DATE	DESCRIPTION
04.29.13	REVISED FOR BID ADDENDUM #01
04/01/13	100% CONSTRUCTION DOCUMENTS

SUWANNEE COUNTY SCHOOL BOARD	
SUWANNEE HIGH SCHOOL COURTYARD RENOVATION	
1314 PINE AVE., SW	LIVE OAK, FLORIDA
NEW COURTYARD FLOOR PLAN	
drawn 04/02/13 CNK	checked
approved

A-1.0

NEW COURTYARD FLOOR PLAN

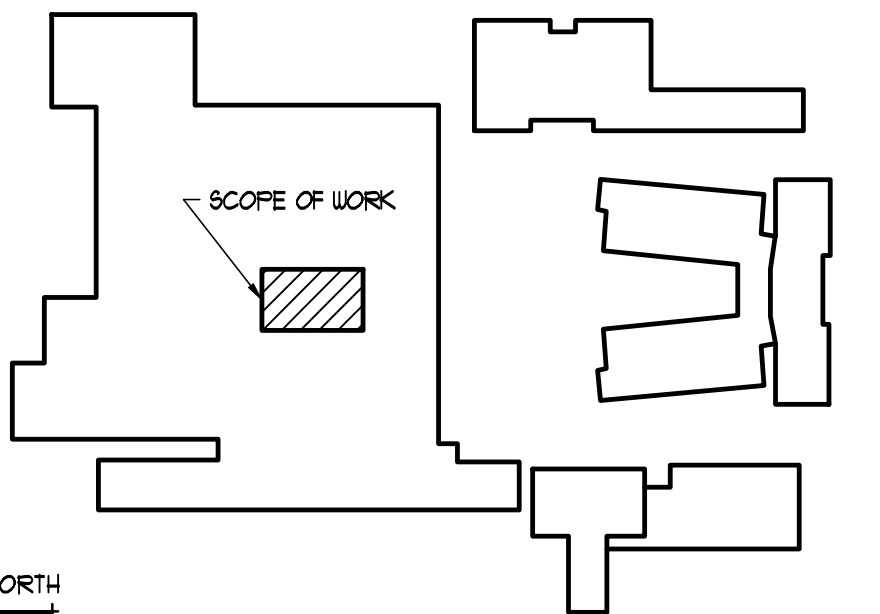
PROVIDE FLAT TOP ALUMINUM THRESHOLD AT TRANSITION BETWEEN NEW TERRAZZO TILE AND EXISTING

PROVIDE ONE (1) HOUR RATED DRY WALL PARTITION FOR THE CROSS CORRIDOR WALL AT DOOR MARK "A".
